12/2014 Product News 7
DVR/NVR/HDVR/DVS 8
1. Release DS-67xx Encoder Firmware v1.2.3_141203 8
2. Release DS-76xxE1/E2 New PoE NVR USA GUI Firmware v3.0.6_141128 8
DOCUMENT 9

12/2014 Product News

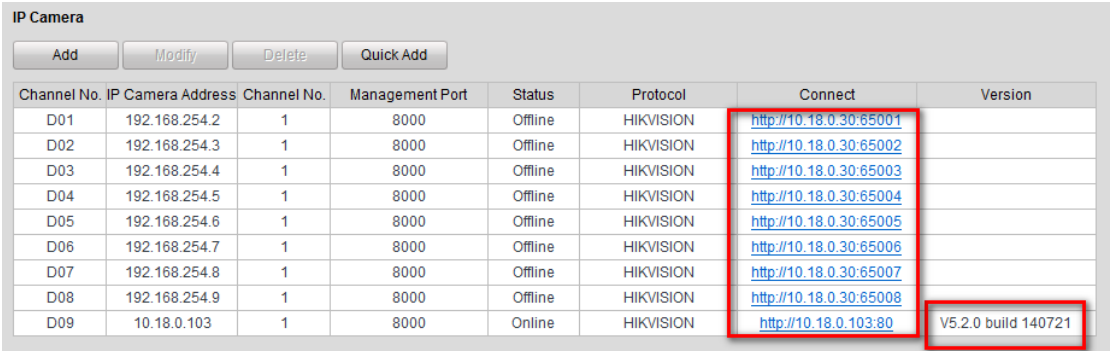
1. IPC version information can be displayed in web UI;

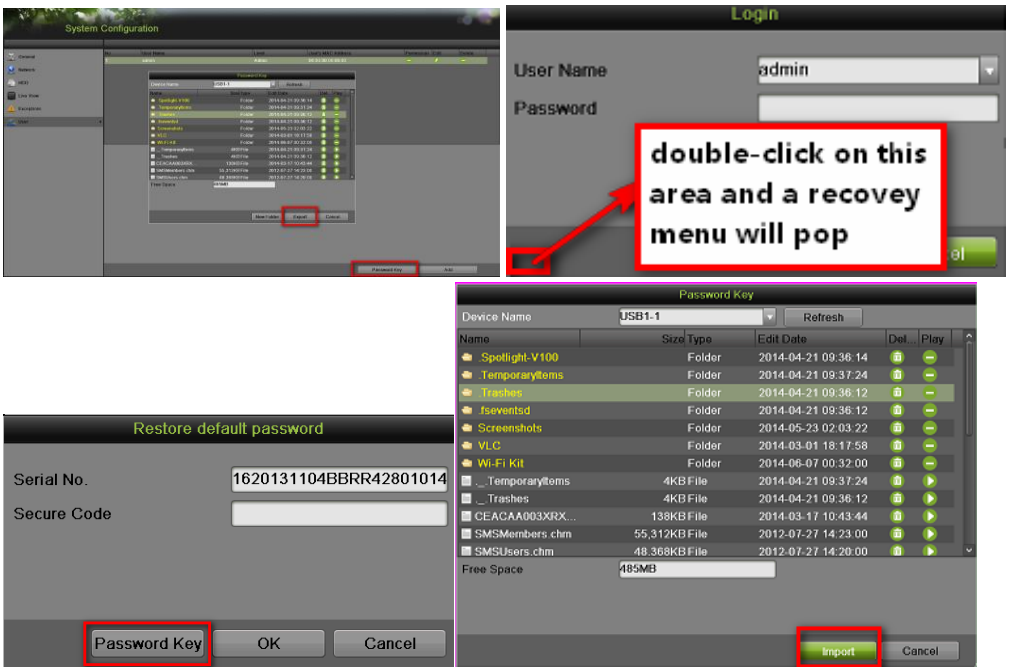
4. Password recovery: A password recovery file can be exported in user configuration menu after user logs in with admin account. With this recovery file, user can reset password in the password recovery menu.

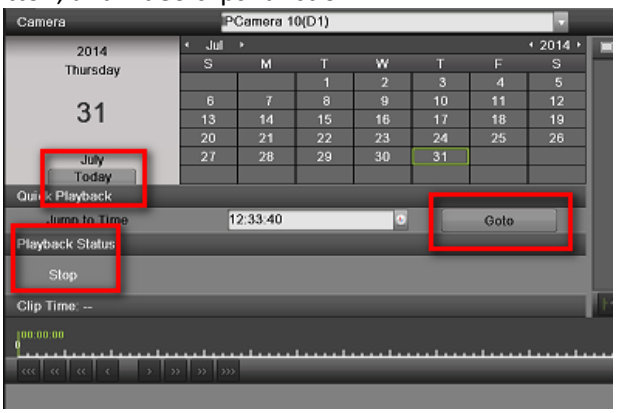
13. Modification of Playback menu: Added today button, time go-to button, playback status. Modified play button, and video clips function.

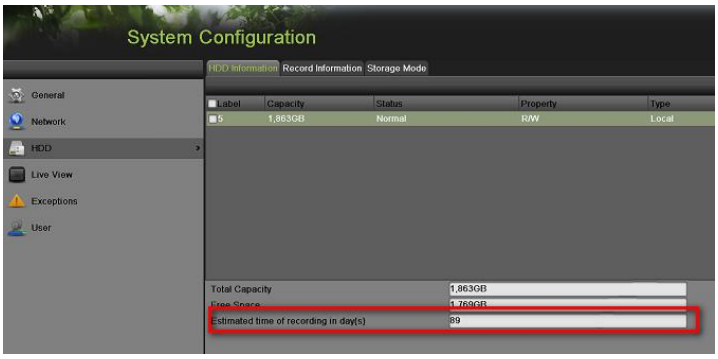
16. Added sub stream correction function.
17. Added display remaining record time in both HDD management and camera management menus.(display N/A if no IPC);

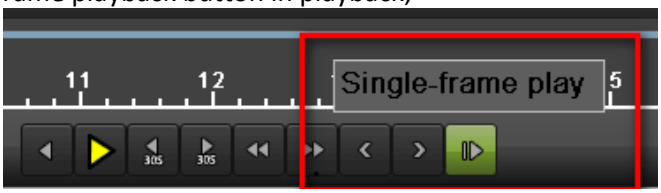
18. Added Single Frame playback button in playback;

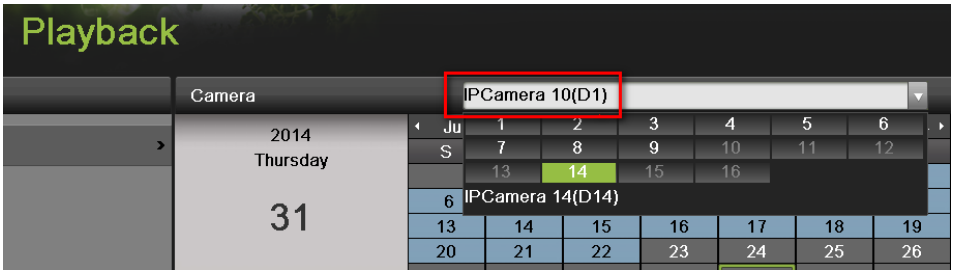
19. Display channel name under channel selection box and in playback sidebar(no changes in web UI);

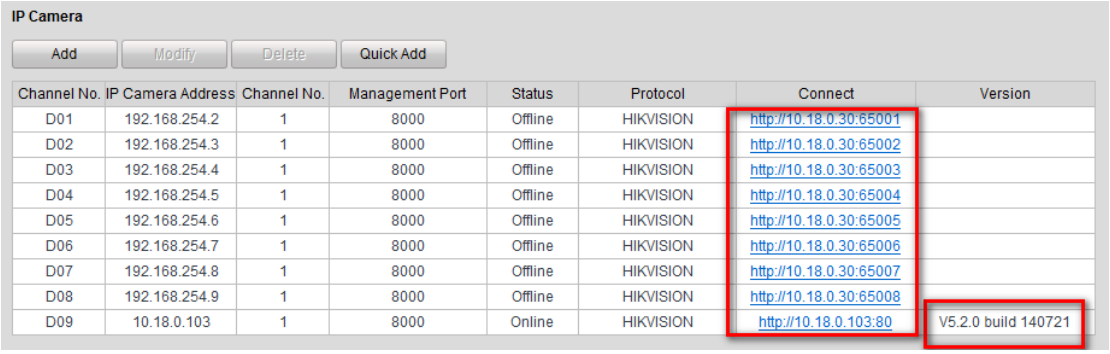
6. Support up to 4-channel playback;
7. IPC version information can be displayed in web UI;

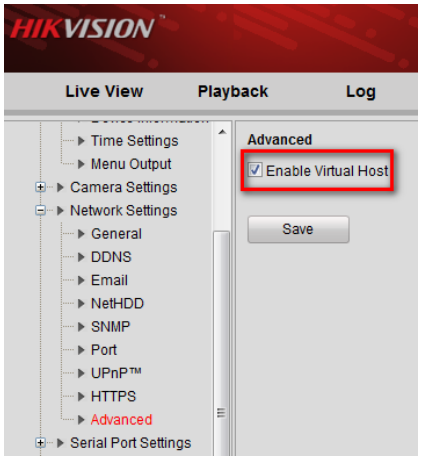
8. Keep the same as Native UI in terms of record schedule type colors;
9. **Added virtual host function**. Disable virtual host by default.

Go to Configuration->Network Settings->Advanced->Enable Virtual Host if needed.

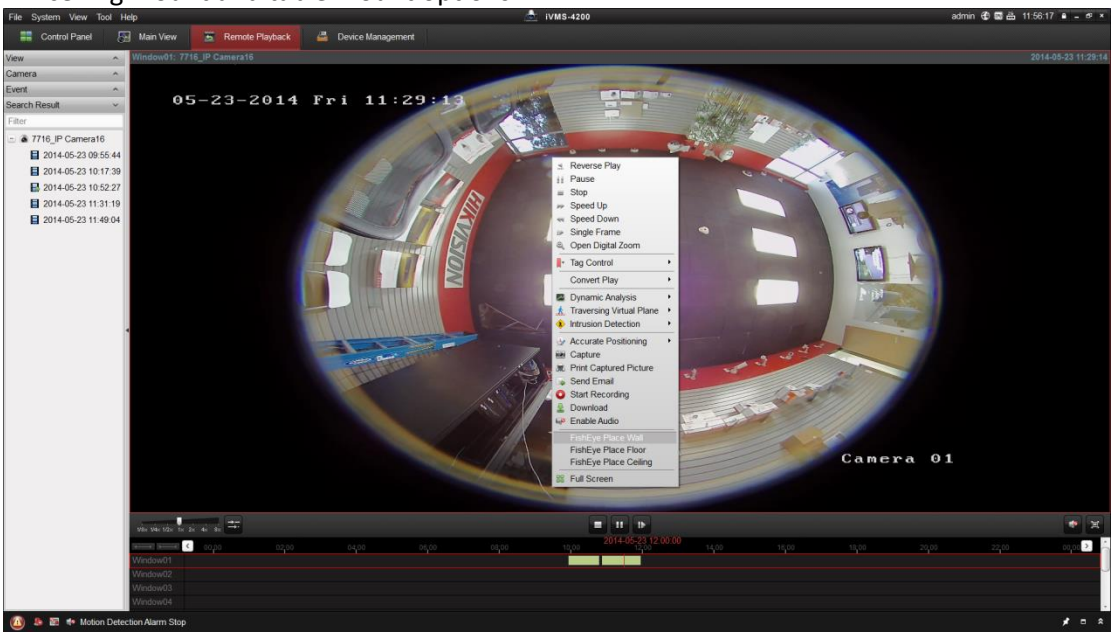
Support de-warping fisheye camera records in playback. Payback de-warp has wall mount, ceiling mount and table mount options.

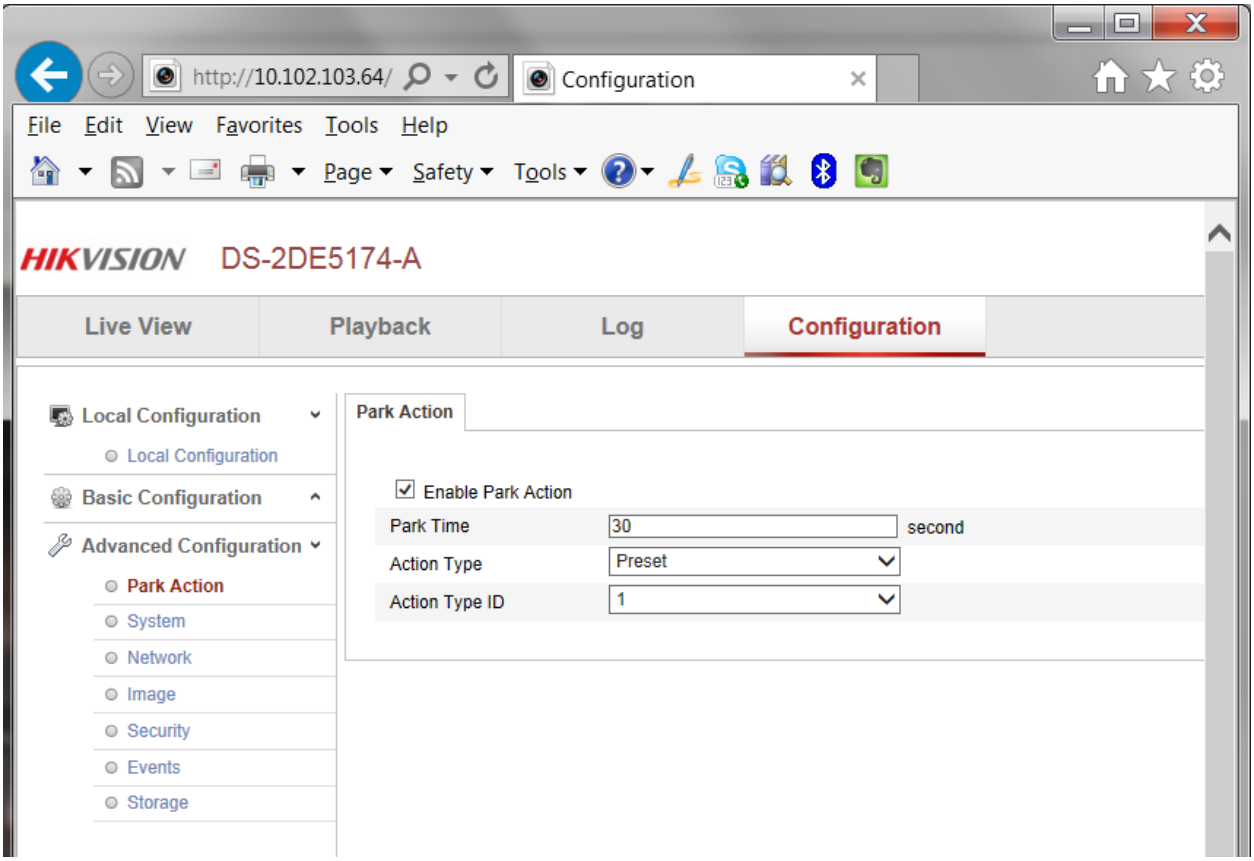
1. Resolved sometime image inverted issue.
2. Add home position (parking) time configuration feature.

In PTZ web component “Advanced Configuration” – “Park Action”, you can setup park action.
